1 ELEVATION VIEW @ ENTRY DOOR - EXTERIOR
 SCALE: 1"=1'-0" ARCH REF: N/A

MATERIALS			
WOOD:	TBD		
WOOD VENEER:	TBD		
DOOR PANEL CORE:	MR50 MDF		
HARDWARE			
HINGES:	TBD		
DOOR BOTTOM:	TBD		
GLASS			
DOOR GLASS:	1/2" TEMPERED GLASS		
FINISHES			
FINISH TO MATCH APPROVED SAMPLE			
EA Custom Millwork 76 Sutton St PO Box 507 Northbridge, MA 01534 www.eacustommillwork.com everett@eacustommillwork.com			
SUBMITTAL		.	
SUBMITTAL (REVISED)		.	
LATE REVISION		.	
Since wood is a natural material, variations in color, texture, & grain may occur. (See AIA section 100) architectural millwork is a finish trade & installation should follow other trades in a controlled environment. Damage by other trades or from being subject to extreme conditions (relative humidity below 25% or above 55%) will result in additional costs and or void the warranty. (See AIA section 1700)			
64 COMMONWEALTH AVE.			
DESIGN		CONTRACTOR	
EA		EA	
DATE	DRAWN BY	JOB #	SHEET
05-16-24	MDS	.	1 of 4
SCALE	AS NOTED

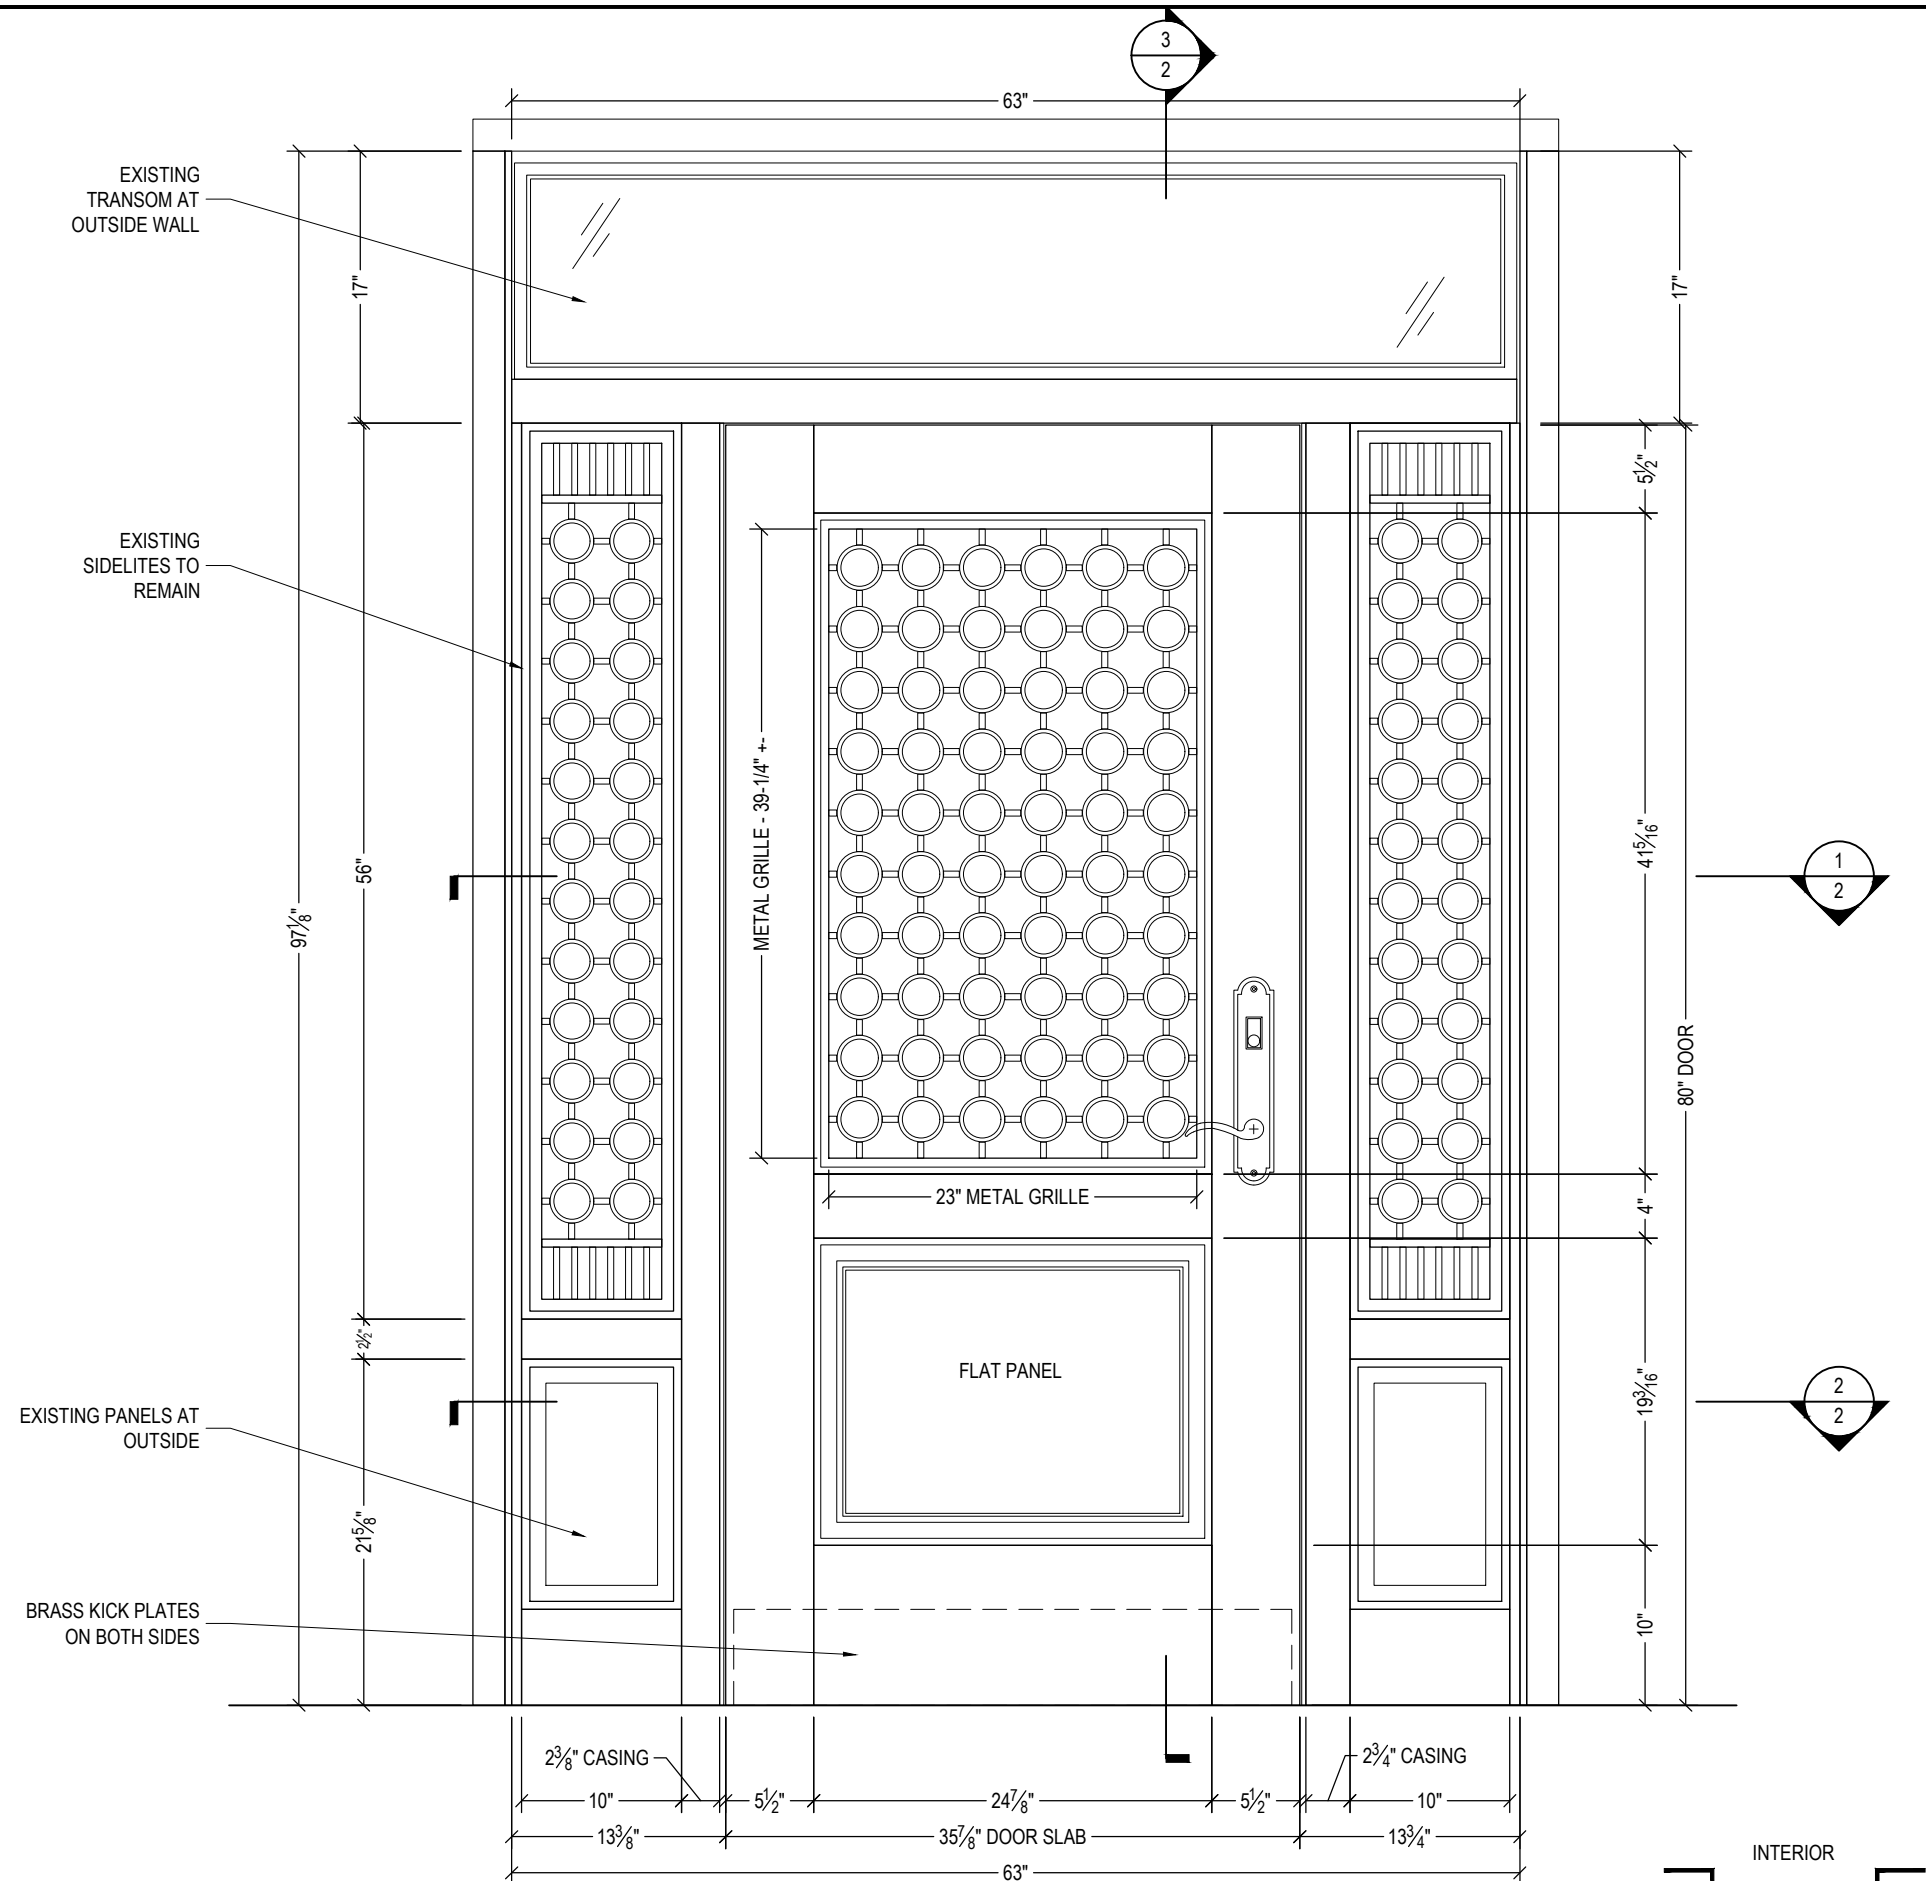
Open transom
and install clear
tempered glass

64
Replace door

Keep existing sidelights

Remove and replace mismatched/damaged trim
